APPLICATION NO.	FILING DATE	FIRST NAMED INVENTOR	ATTORNEY DOCKET NO.	CONFIRMATION NO.
10/664,195	09/17/2003	Todd M. Bjork	M81.12-0068	3894
27367	7590 03/03/2006	EXAMINER		
WESTMAN CHAMPLIN & KELLY, P.A. SUITE 1400 - INTERNATIONAL CENTRE 900 SECOND AVENUE SOUTH			RAMANA, ANURADHA	
			ART UNIT	PAPER NUMBER
MINNEAPOLIS, MN 55402-3319			3733

Application No.	Applicant(s)				
055	10/664,195	BJORK ET AL.				
Office Action Summary	Examiner	Art Unit				
	Anu Ramana	3733				
The MAILING DATE of this communication appears on the cover sheet with the correspondence address Period for Reply						
A SHORTENED STATUTORY PERIOD FOR REPLY IS SET TO EXPIRE 3 MONTH(S) OR THIRTY (30) DAYS, WHICHEVER IS LONGER, FROM THE MAILING DATE OF THIS COMMUNICATION. - Extensions of time may be available under the provisions of 37 CFR 1.136(a). In no event, however, may a reply be timely filed after SIX (6) MONTHS from the mailing date of this communication. - If NO period for reply is specified above, the maximum statutory period will apply and will expire SIX (6) MONTHS from the mailing date of this communication. - Failure to reply within the set or extended period for reply will, by statute, cause the applica

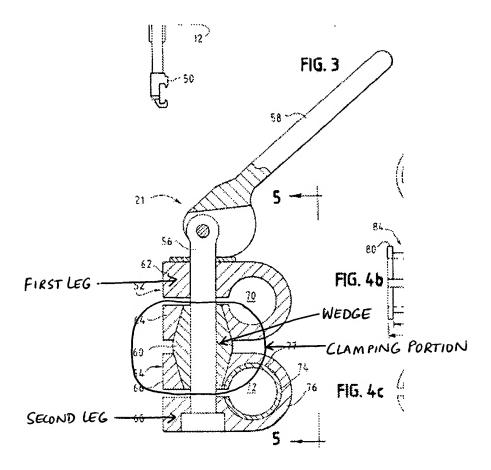
Regarding the rejections of claims 1 and 9 under 35 USC 102(b) by Farley et al., the wedge member or "actuating mechanism" 60 of Farley et al. is disposed in the intervening space or "between" the first and second clamping members and has a handle 58 attached or "connected" thereto via shaft 56 (Fig. 3).

Regarding the rejection of claim 15 under 35 USC 102(b) by Farley et al., wedge 60 of Farley et al. forces the legs of each of the clamping members towards each other, i.e., in opposing directions. See Fig. 3 from Farley et al. marked up on the following page to clarify Examiner's interpretation of Farley et al.
